# RENESAS TECHNICAL UPDATE

Product Category	MPU&MCU		Document No.	TN-SH7-A543A/E	Rev.	1.0
Title	Limitation for use of SH7710 internal Ethernet DMAC.		Information Category	Technical Notification		
Applicable Product	HD6417710 HD6417712 R4J7710ABG	Lot No.	Reference Document	SH7710 Hardware manual REJ09B0079-0100Z Rev.1.0		
		ALL

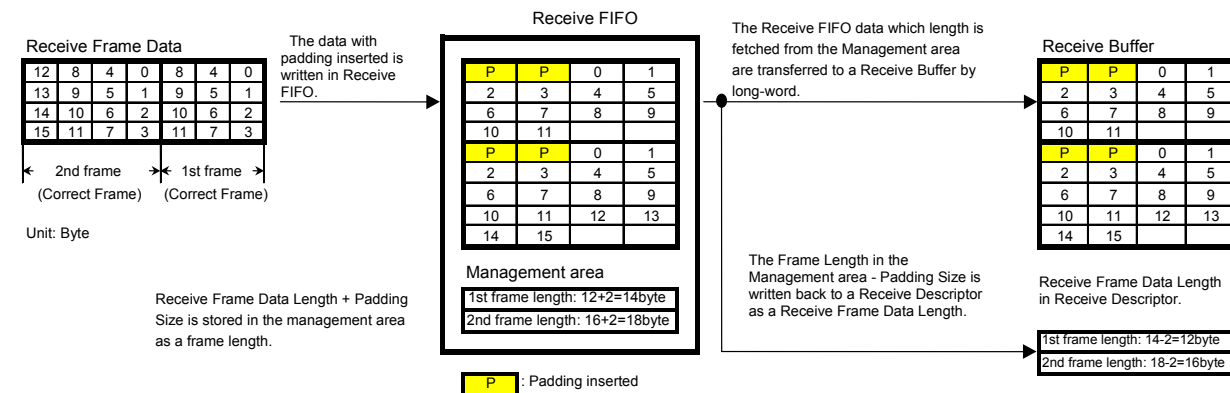
Whether this 4 bytes gap occurs or not depends on the padding size and the byte number of remainder when dividing a receive frame data length by 4 as a table below.

Δ :The error (1) above only occurs.

:The both error (1) and (2) occur.

<The case that 2 bytes padding is inserted at the head of a frame and a CRC error frame is received : the error (1) only>

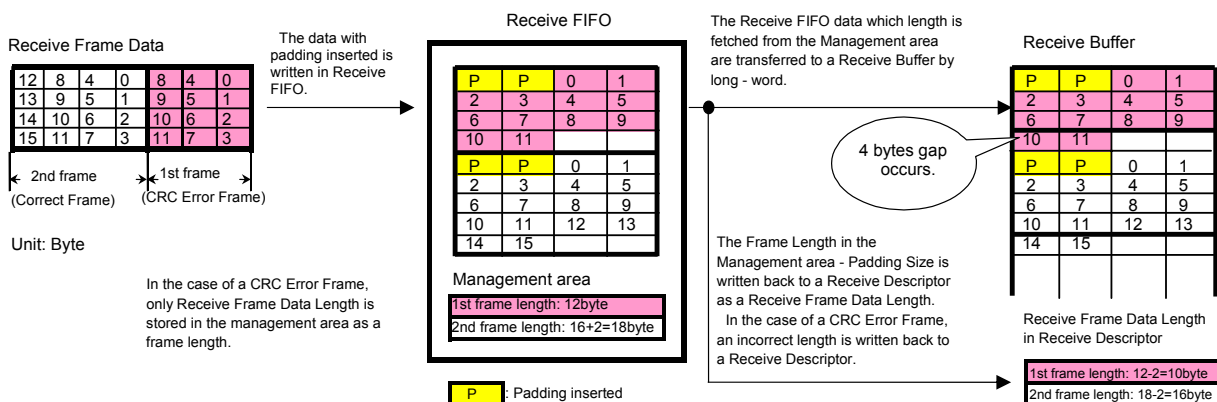
When a CRC error occurs in the case the receiving data padding insertion function is set enabled, the E-DMAC writes back an incorrect receive frame length, which is the inserted padding bytes short of the correct length, to a Receive Descriptor.

Please do not use the padding insertion function of E-DMAC.

When a CRC error occurs in the case the receiving data padding insertion function is set enabled, please execute a Software Reset by taking the following procedure to recover your system.

- a) Check EtherC/E-DMAC Status Register (EESR) bit 0(CERF) = 1 to confirm a Receive Frame CRC Error.
- b) Execute a Software Reset by setting E-DMAC Mode Register (EDMR) bit 0(SWR) = 1.
- c) Execute an initial set-up of EtherC, E-DMAC and receive descriptors.
- d) Activate a receive function of E-DMAC by setting EDRRR bit 0(RR) = 1.
- e) Start to receive data by setting EtherC Mode Register (ECMR) bit 6(RE) = 1.
